PM73122 AAL1GATOR-32

AAL1GATOR-32 REVISION A DEVICE ERRATA

ISSUE 4: MAY 2001

2.8 When RDB/CSB is Asserted 15 ns Beyond ACKB Certain SBI Interrupt Register Read Cycles Result in Corrupt Data

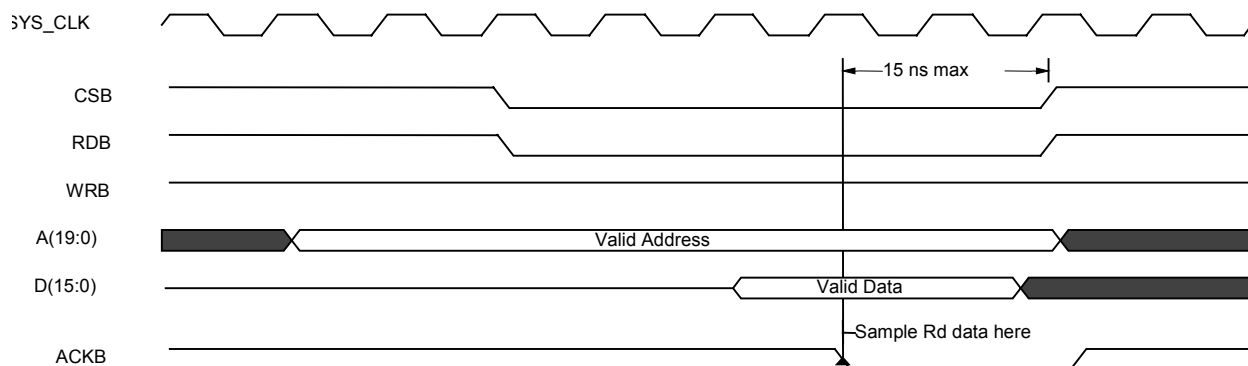
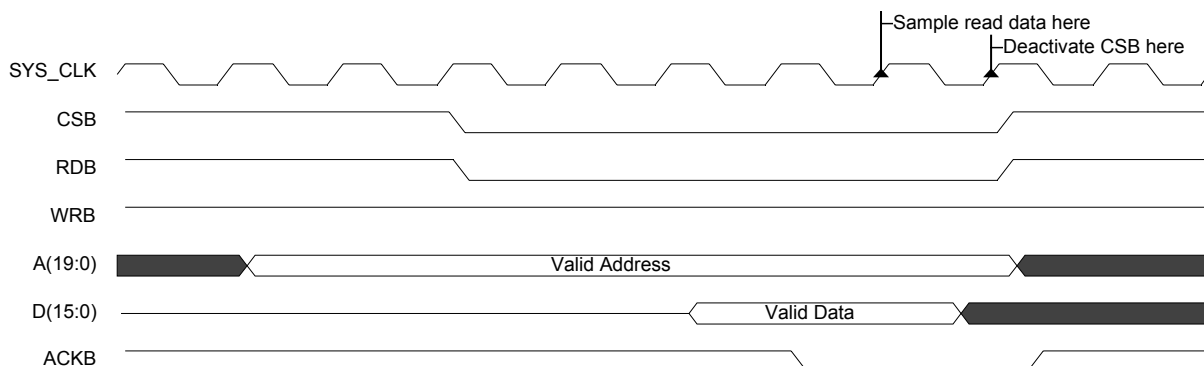
For read cycles of certain SBI Insert/Extract Bus Interrupt registers, if the RDB and CSB signals are held active for more than 50 ns after the falling edge of ACKB the data read may be corrupt; however, the fact that an interrupt occurred is never missed. The corrupt data that is read results in a possibly incorrect association of the interrupt to the actual link that caused the interrupt.

The AAL1gator-32 provides an ACKB signal to indicate when data is ready on chip reads. If the falling edge of ACKB is used to latch the data, and the CSB signal is deactivated within 15 ns of the falling edge of ACKB, reliable reads will occur.

An alternative solution is to lock the SYS_CLK and SBI REF_CLK to a common reference. In this case, if SYS_CLK is used as the processor clock, data can be latched reliably using the first rising edge of SYS_CLK while ACKB active. CSB should then be deactivated with the following rising edge of SYS_CLK.
